Attachment 1 - PLN17/1061 - 93 - 97 Webb St, Fitzroy - Decisions Plans - Part1.

93 WEBB ST, FITZROY 3065

TOWN PLANNING - RFI RESPONSE
01/03/2018

Application No.: PLN 17/1061
Address of Property: 93 Webb Street, Fitzroy
Planner: Sarah Thomas
Yarra Planning Scheme References: Clauses 43.01 and 22.02
Heritage Overlay No.: HO 334 **Precinct:** South Fitzroy

TOWNHOUSE FACADE ARTICULATION
LEVEL 3

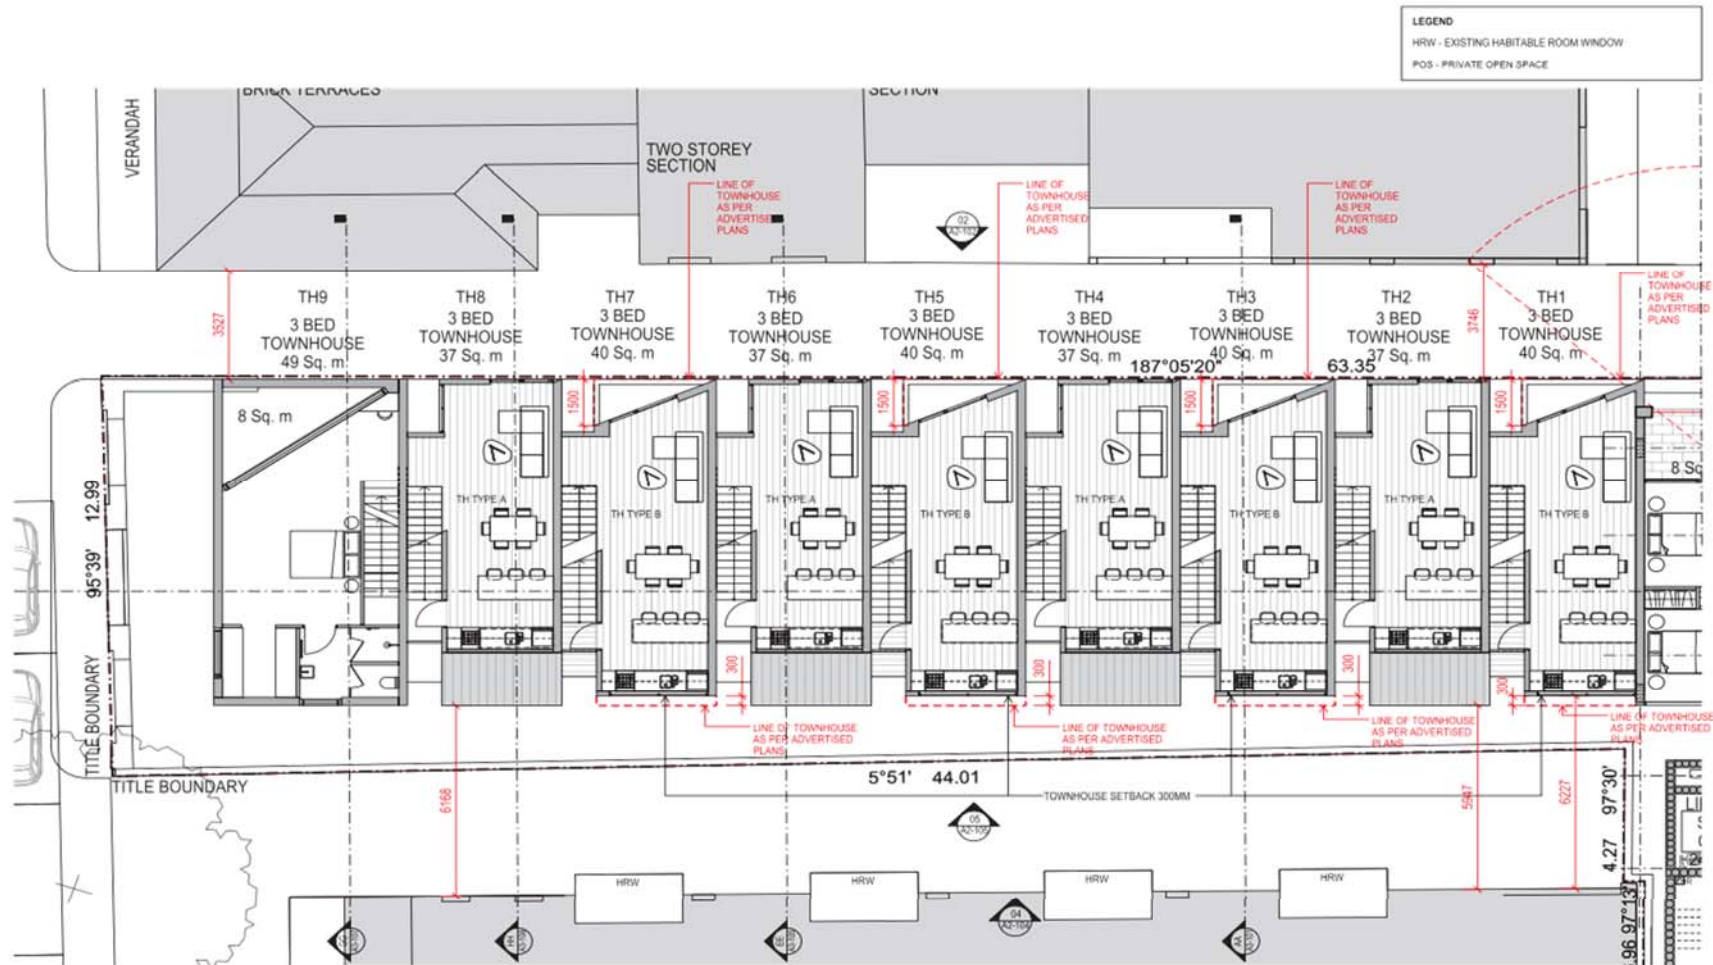
The potential for an increased setback of 300 mm for the townhouses on the west side at Levels 2 and 3 would lessen the visual impact i.e. reduce the visual bulk slightly. (Refer to red line and annotation on "Townhouse façade articulation Level 3 drawing in the revised plans).

APARTMENT FORM REDUCTION
LEVEL 5

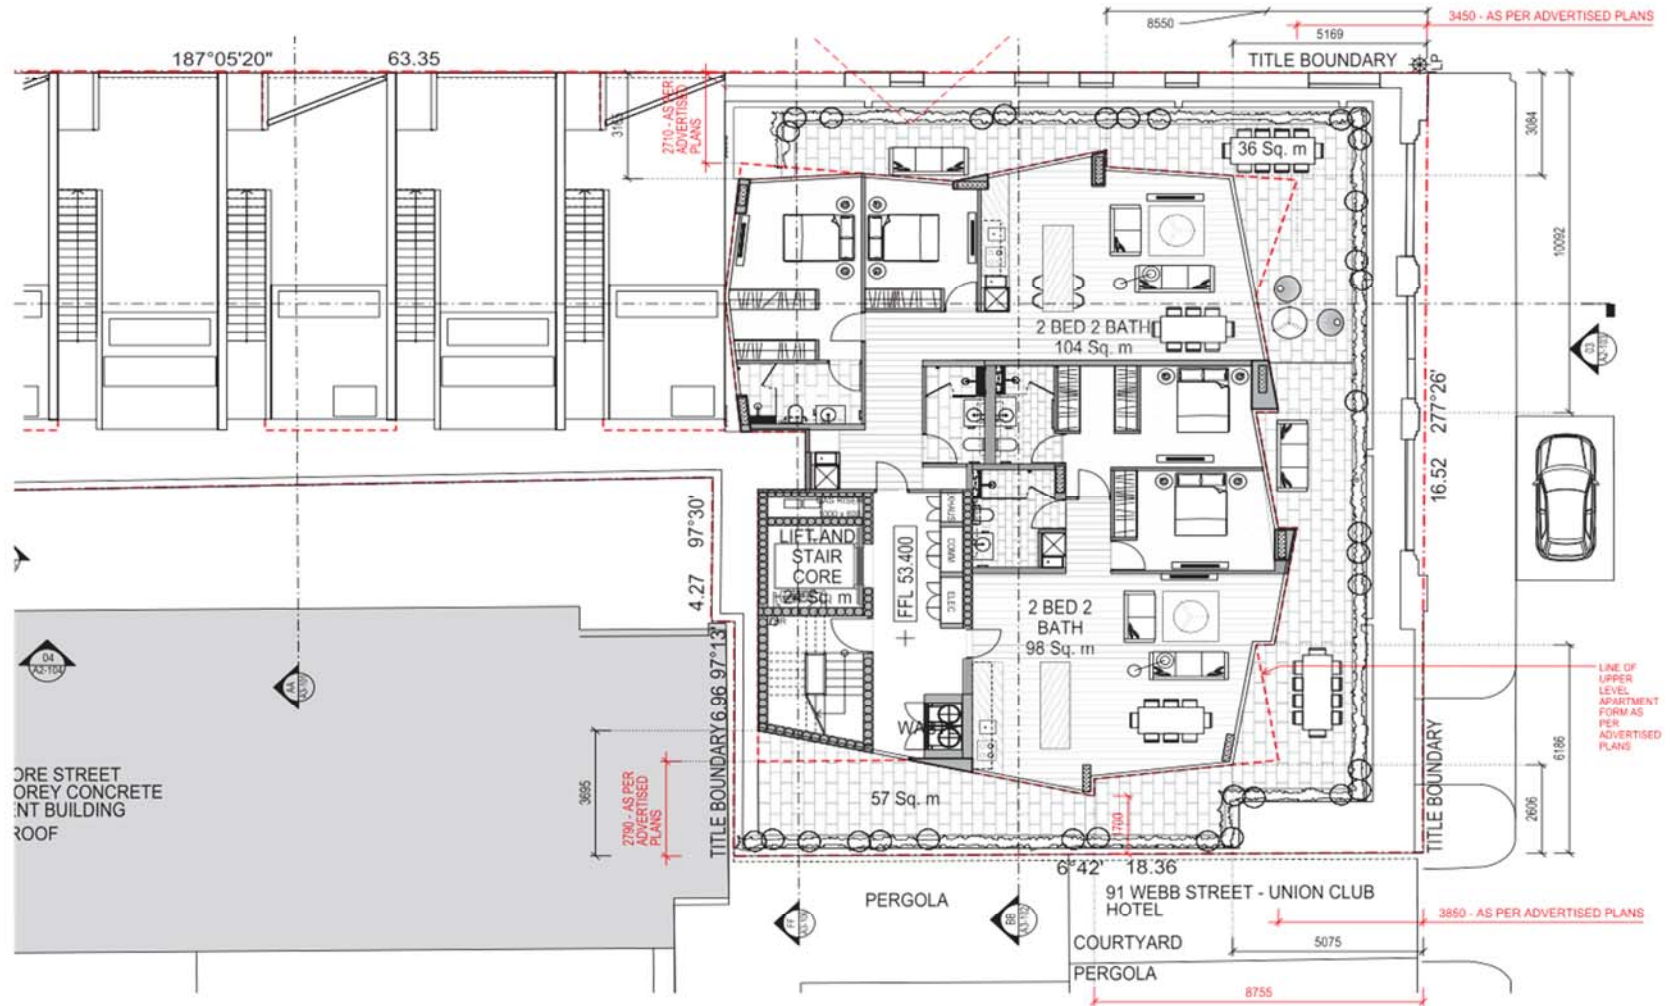
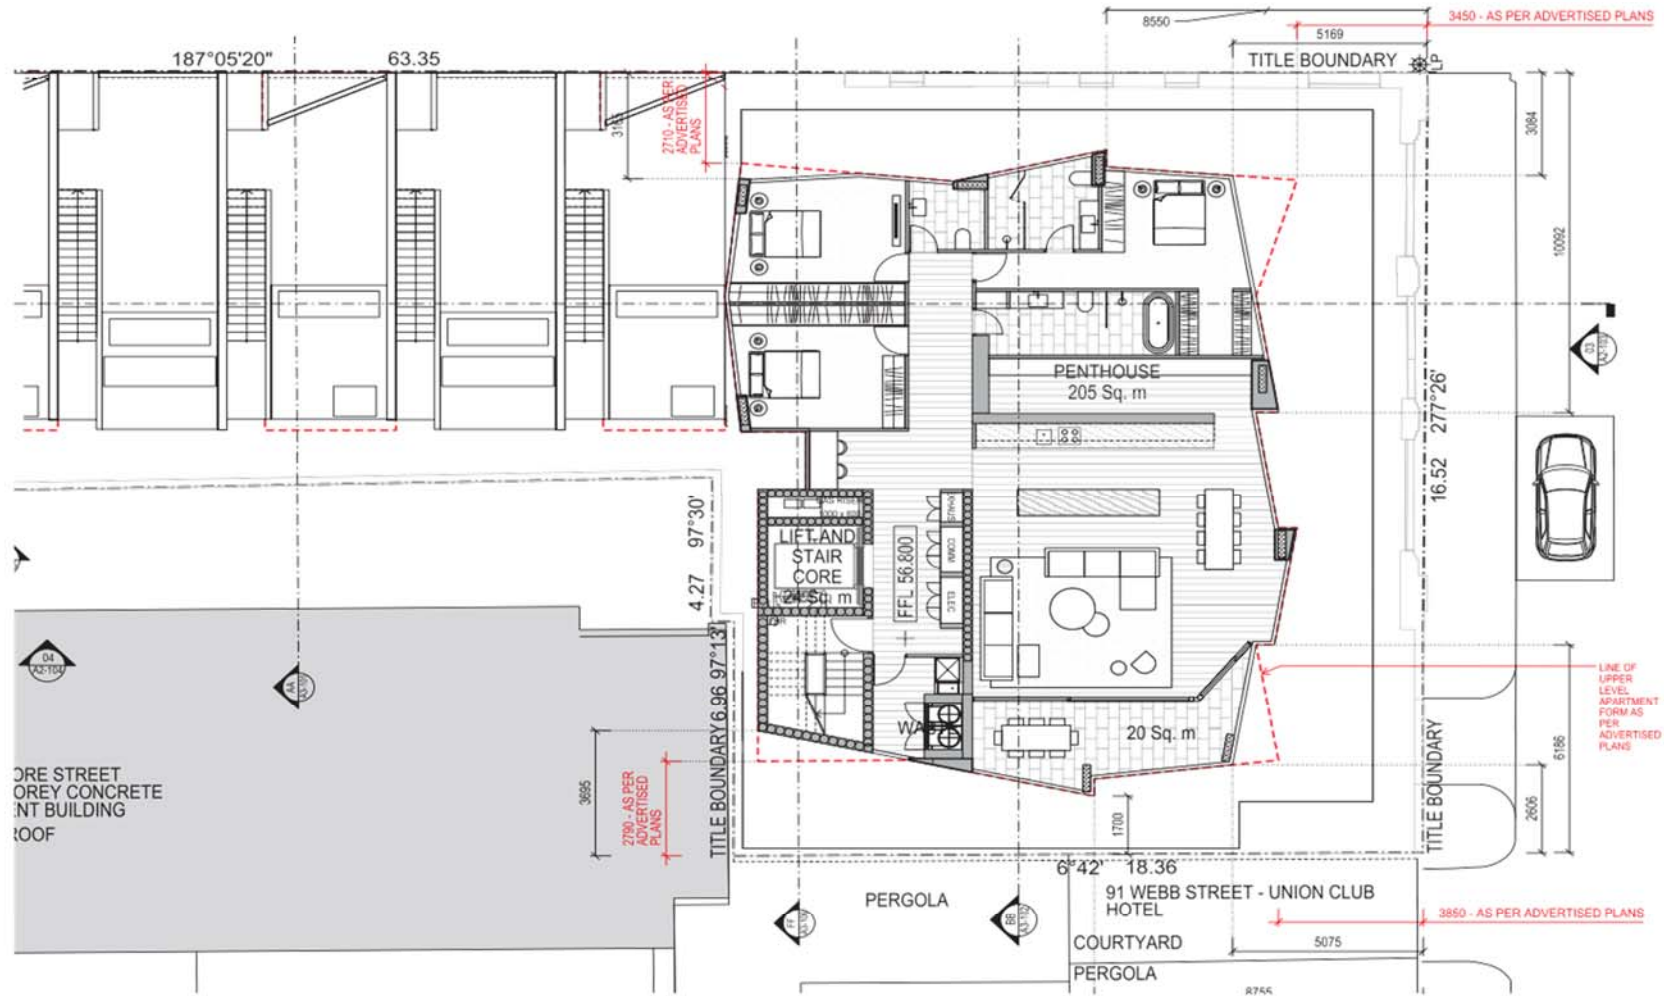
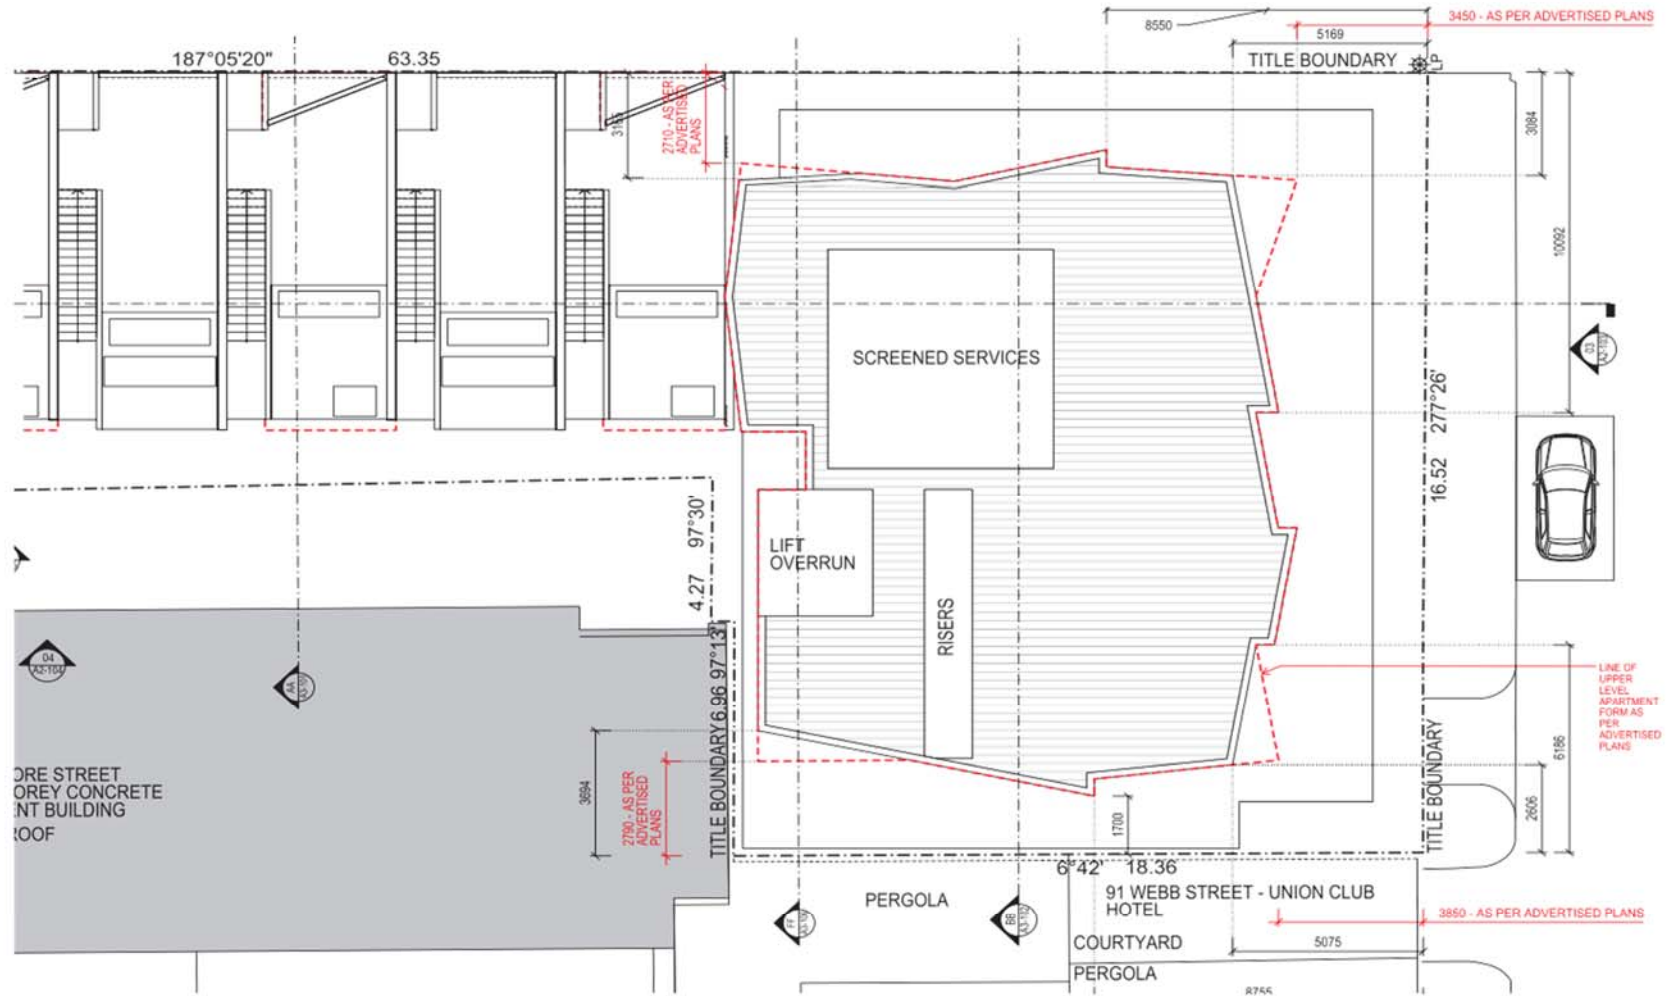
At Level 5 the articulated apartment plan form commences with a slightly increased setback from below, (ranging from 3.6 to 3.5 to 4 metres) and with east and west side setbacks. At Level 6 the setbacks are generally similar. Of themselves they are not unacceptable but in combination with the additional height of these levels they do not assist in reducing the visibility and/or visual bulk of Levels 5 and 6 which is the principal heritage concern.

Levels 5 and 6 have not been deleted as previously recommended. They are located at a critical interface with the low-rise residential area of Fitzroy as compared with the townhouses which have a much more discrete siting. The slight reduction in setbacks of Levels 5 and 6 as now proposed will have minimal effect (refer to the red line shown on Apartment form reduction Level 5 – 6. The proposed setbacks do little if anything to reduce the visibility and visual bulk and instead these levels attract attention as is evident in the revised comparative perspectives taken from the corner of Webb and Gore Streets. In this view the height exceeds that of the apartment building on the corner of Charles and Gore Streets which has set a precedent for being the highest building in the immediate residential vicinity of Fitzroy.

Delete two upper levels of the apartments.
